Valley of the Winds Wind Farm (SSD-10641)

Response to request for information

April 2024

Project name **Valley of the Winds response to request for additional information**
Project no. **318001172-014**
Recipient **Department of Planning, Housing and Infrastructure**
Document type **Report**
Version **V1.0**
Date **5 April 2024**
Prepared by **Tawna Krause**
Checked by **Belinda Sinclair**
Approved by **Belinda Sinclair**
Description

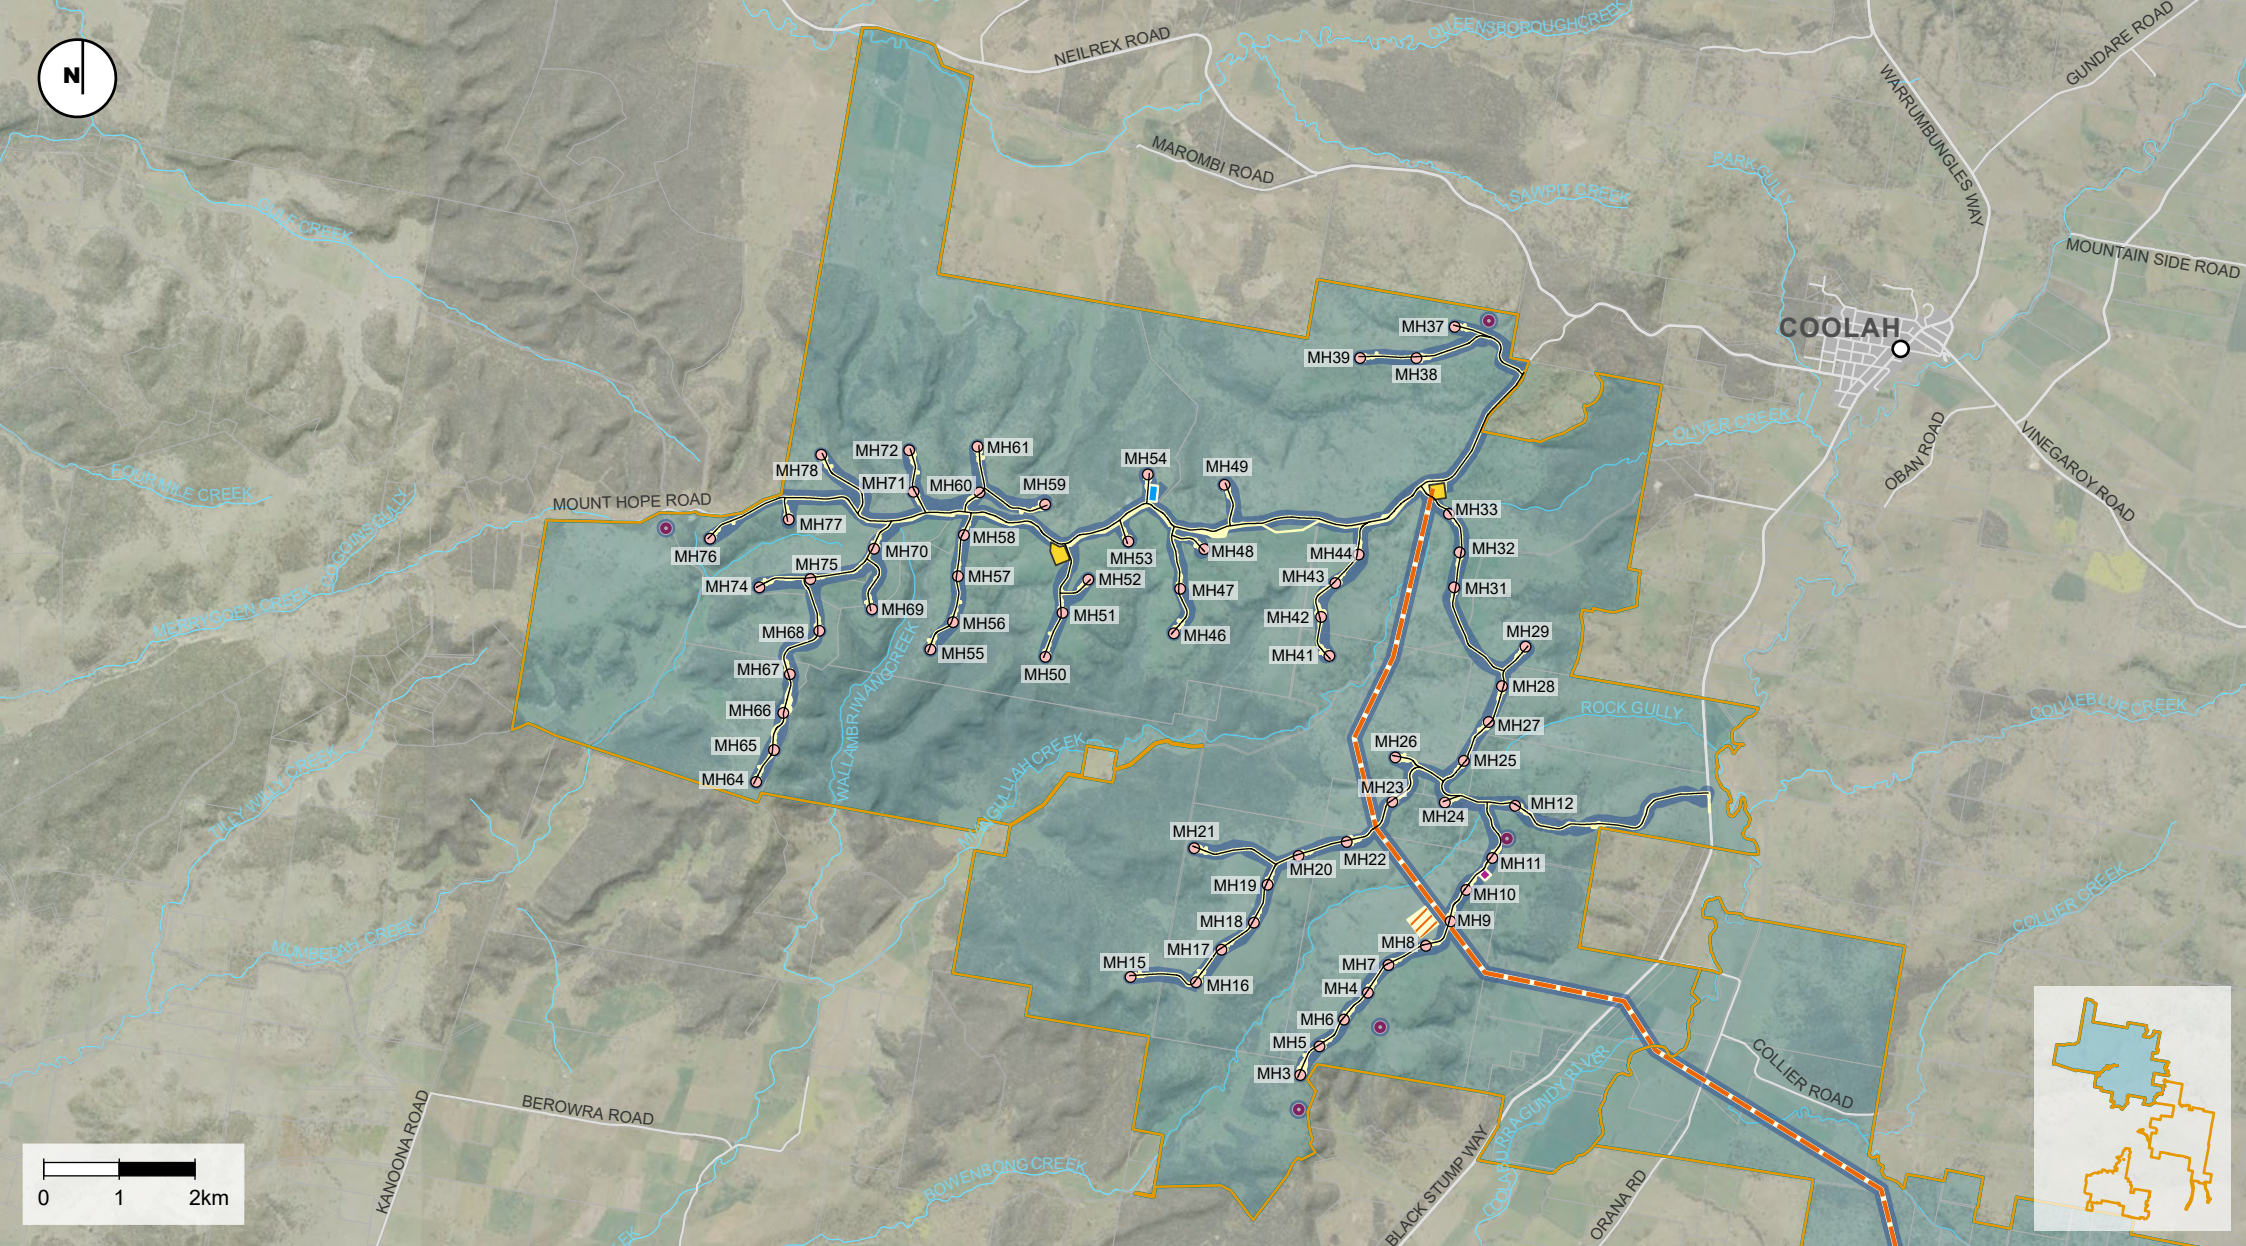
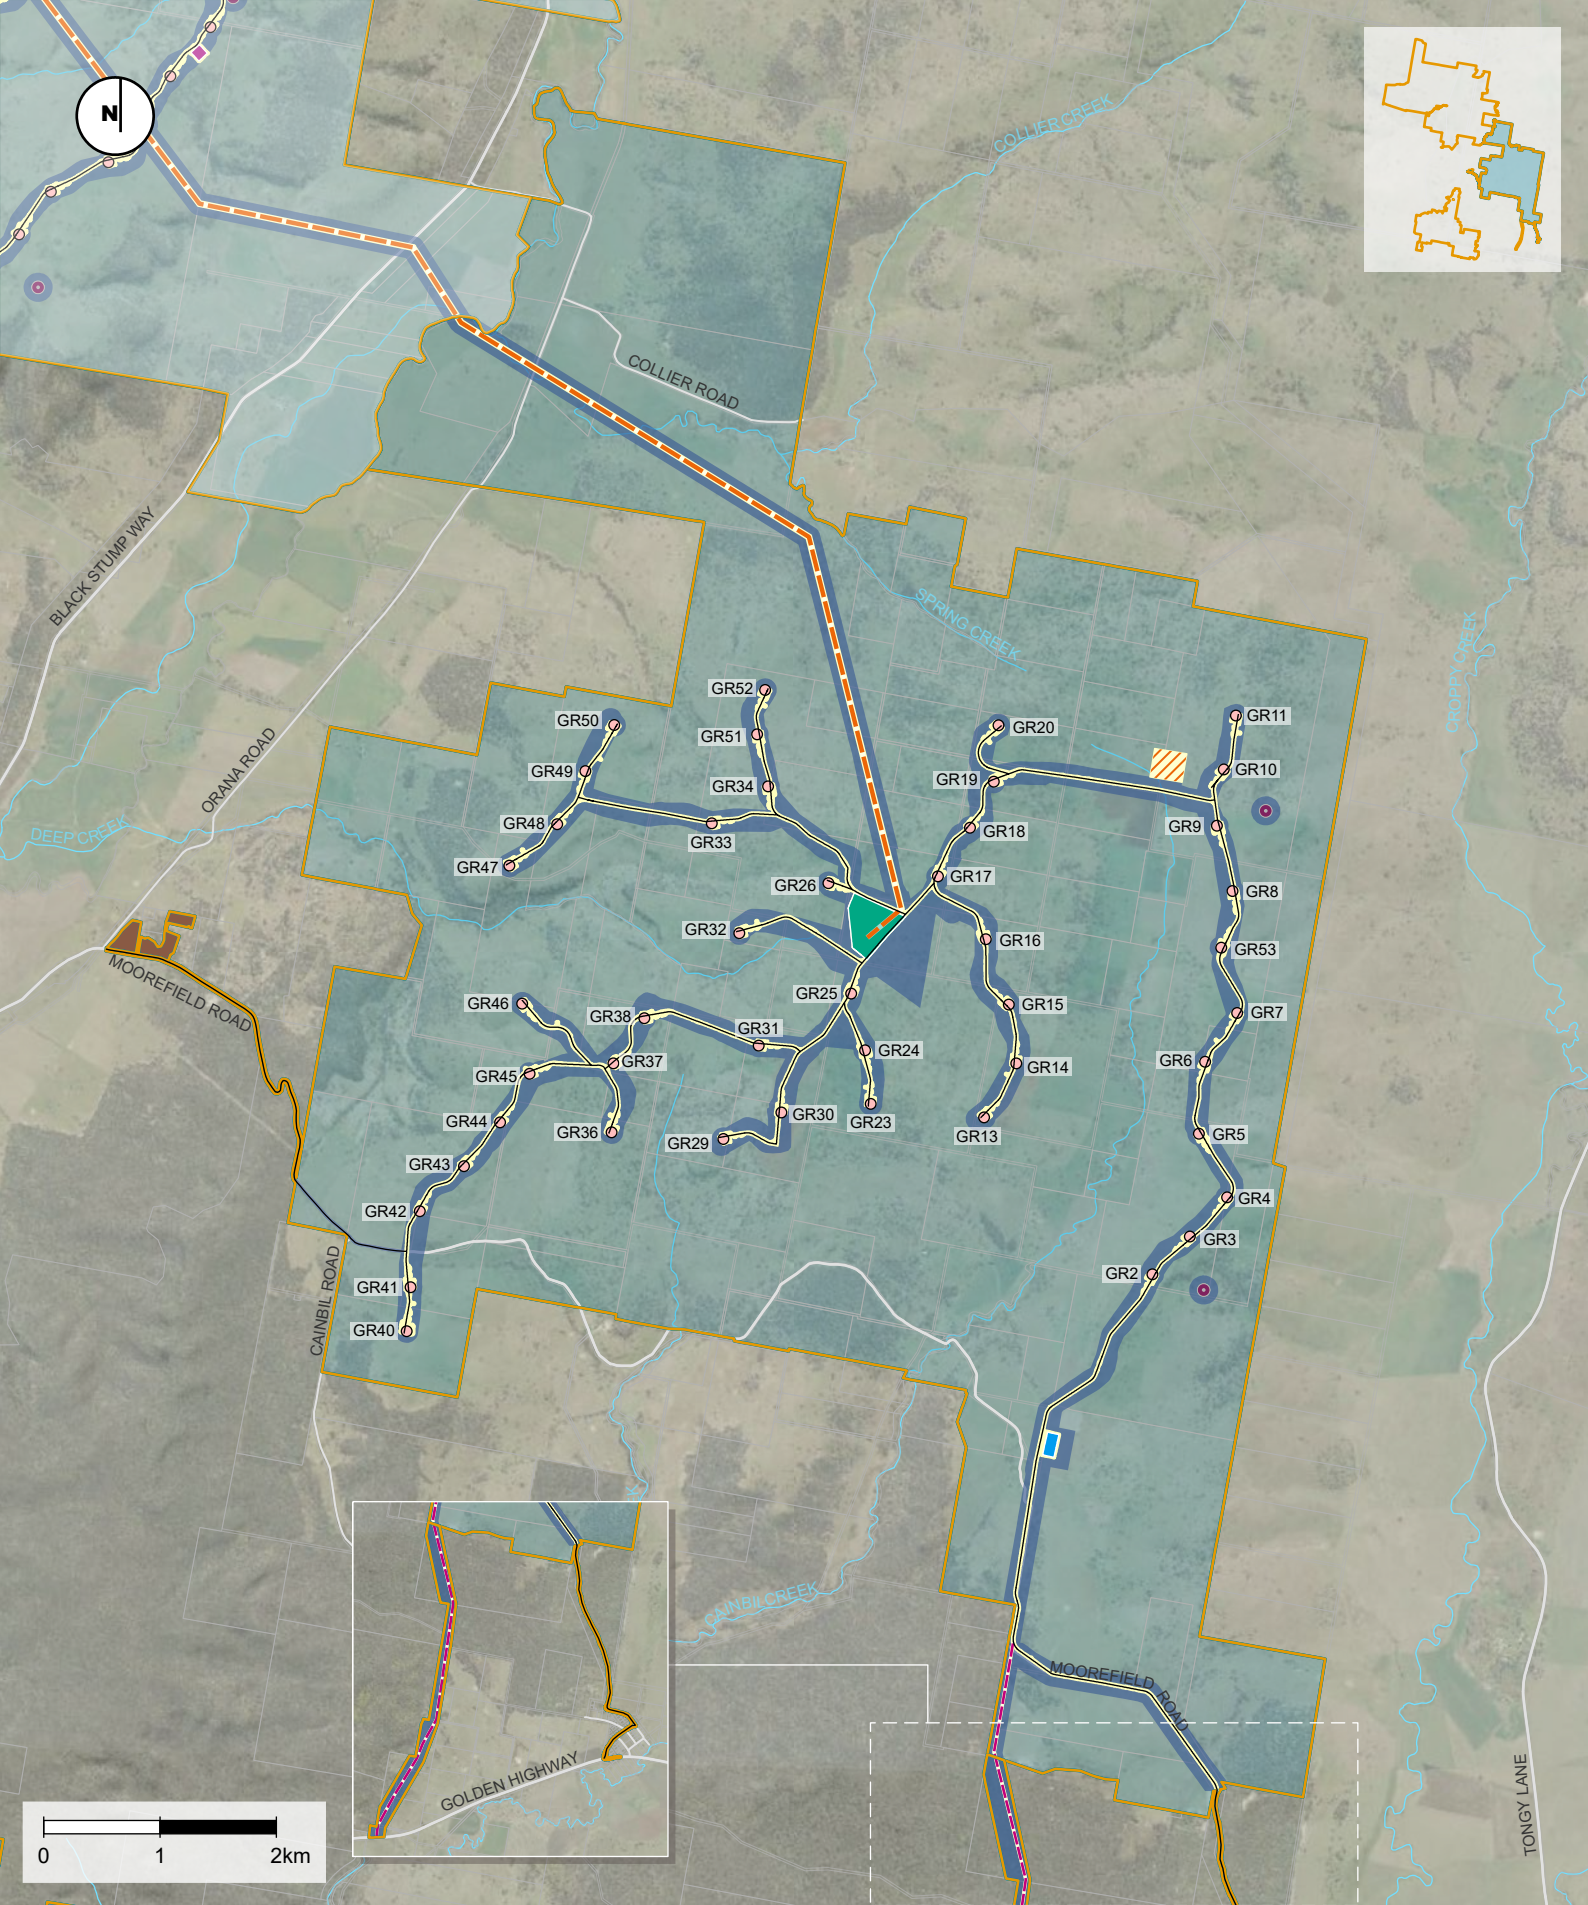
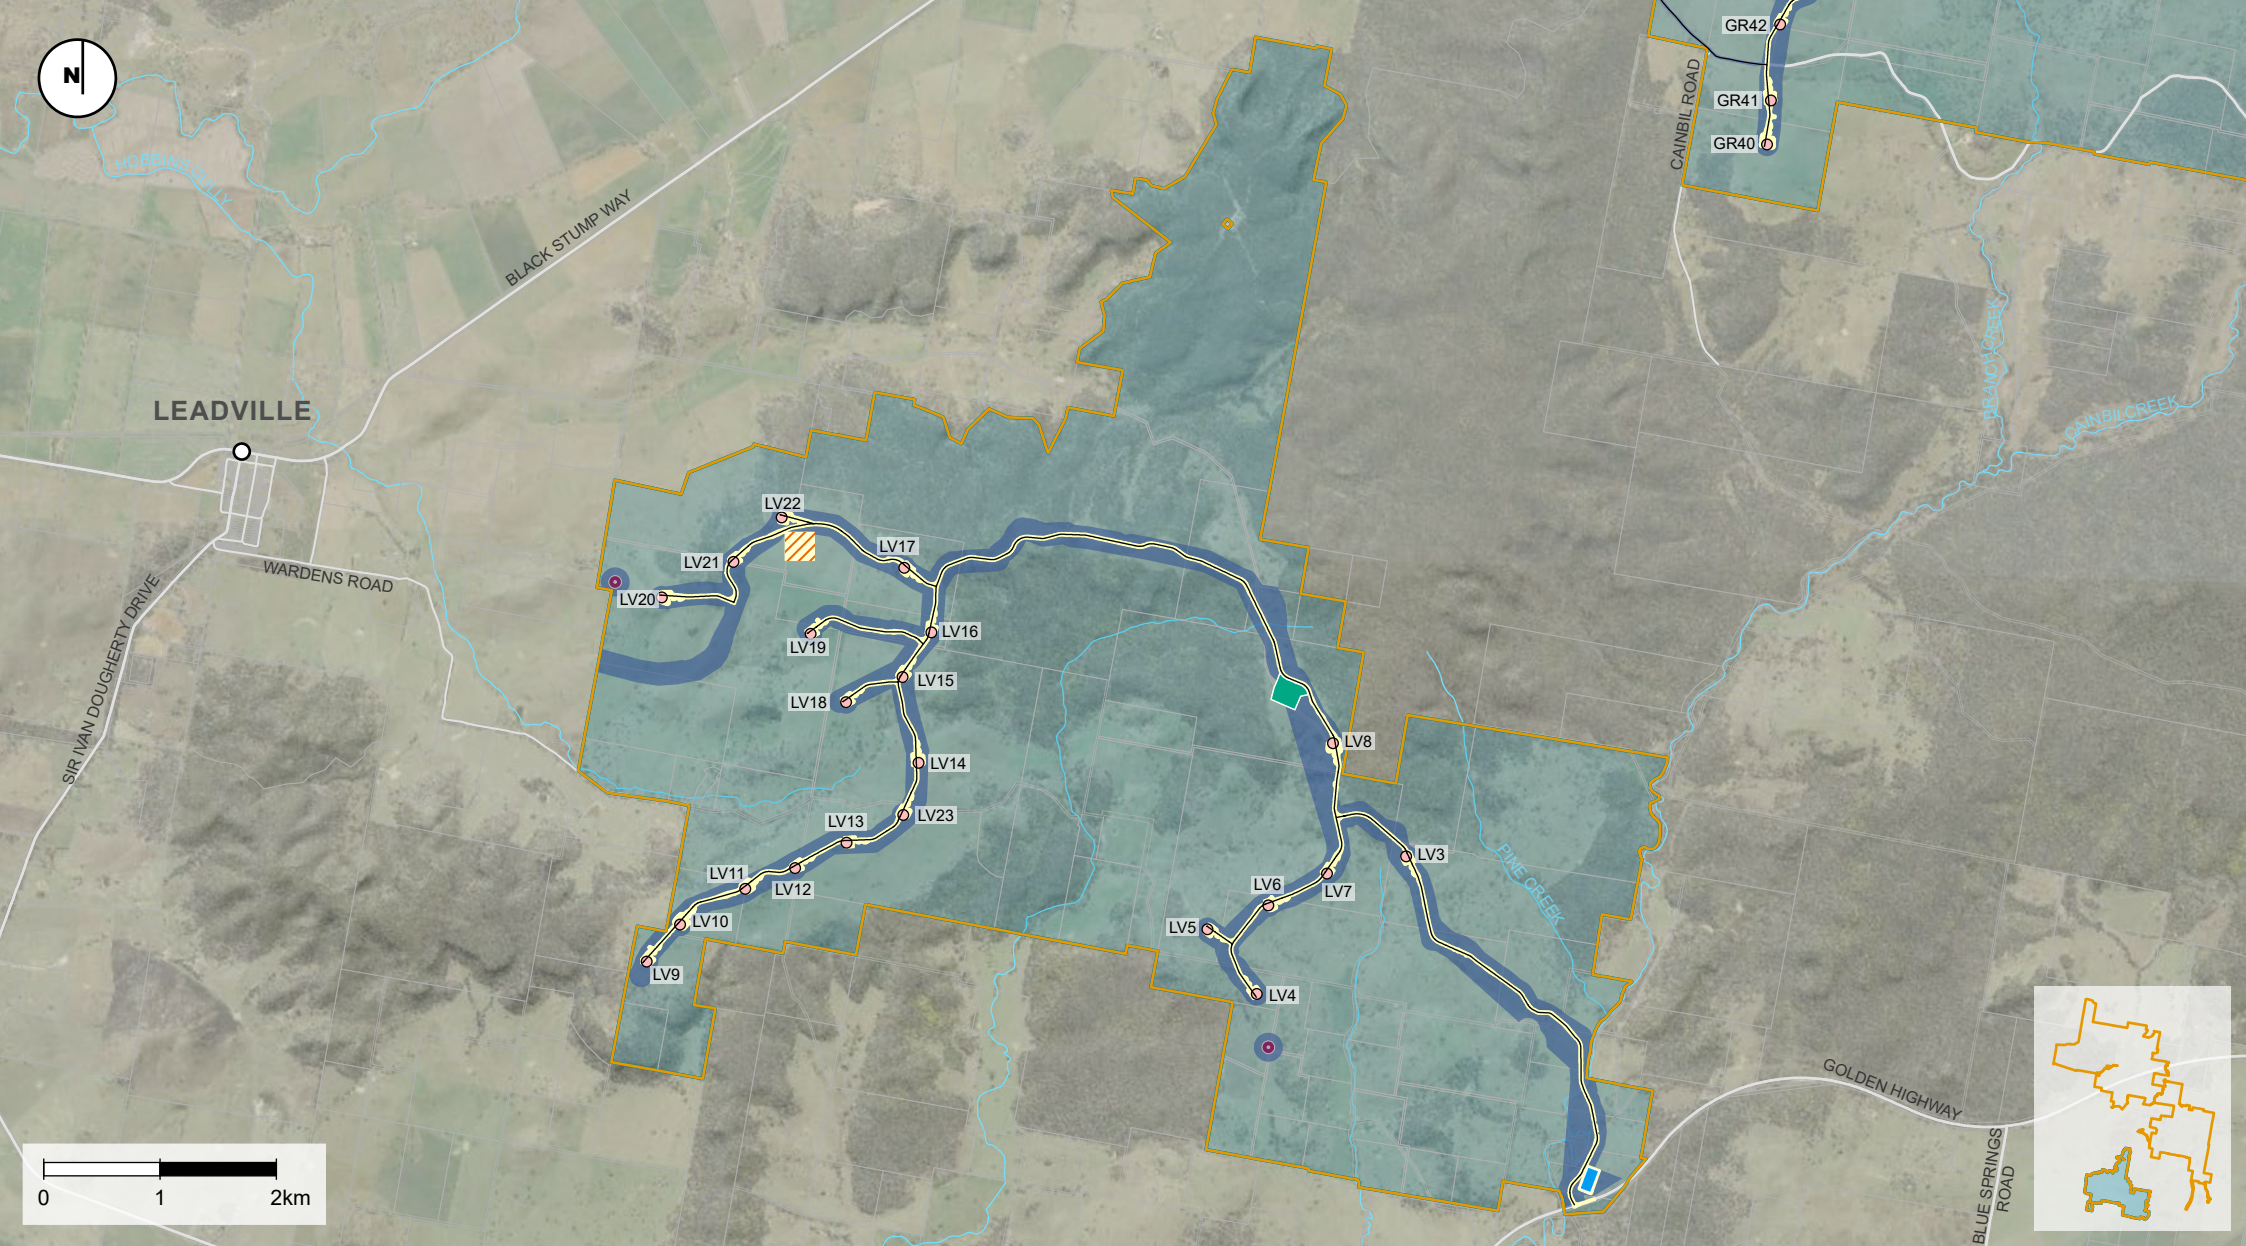
Update project figures to show the development corridor and disturbance footprint and provide spatial files for the amended project as per the Department's State Significant Development Guidelines 2022.

Updated figures including the development corridor and the indicative construction footprint are included in **Figure 2-2** to **Figure 2-5**.
